# Dolby Laboratories Inc

Field Bulletin 198

## Model CP500

### Cat. No. 661 Optical Preamp Software Upgrade (IC509)

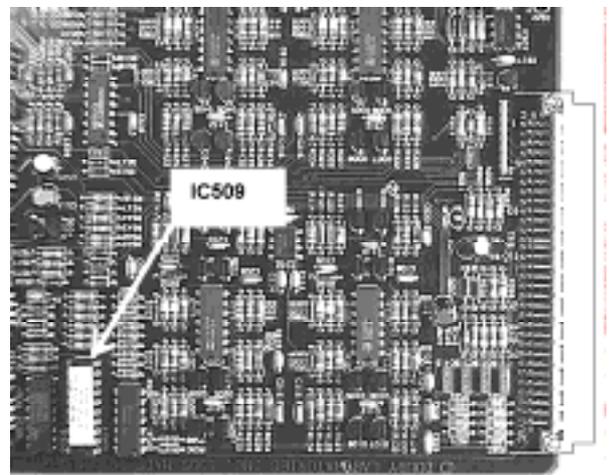
- The CP500 ignores the first projector changeover command received after power is turned on.

Early Cat. No. 661 optical preamp boards contained a programming error which caused the preamp to ignore the first projector changeover command received after power-on. This modification involves removing the programmable logic array IC 509 and replacing it with an updated one.

2. With the connector on the right hand side, the location of IC509 is shown in this photograph. The IC has a printed label.

3. Note the orientation of the IC on the board then carefully remove and replace it with a correctly programmed part (Dolby Part Number 84149, available at no charge from Dolby offices ). **The IC is extremely sensitive to static electricity. Be sure to remove any static on your hands by touching the chassis of the unit before handling it.** IC509 is mounted in a socket in most boards. *If IC509 is soldered into your board, return the board to Dolby for exchange rather than attempting to desolder it.*
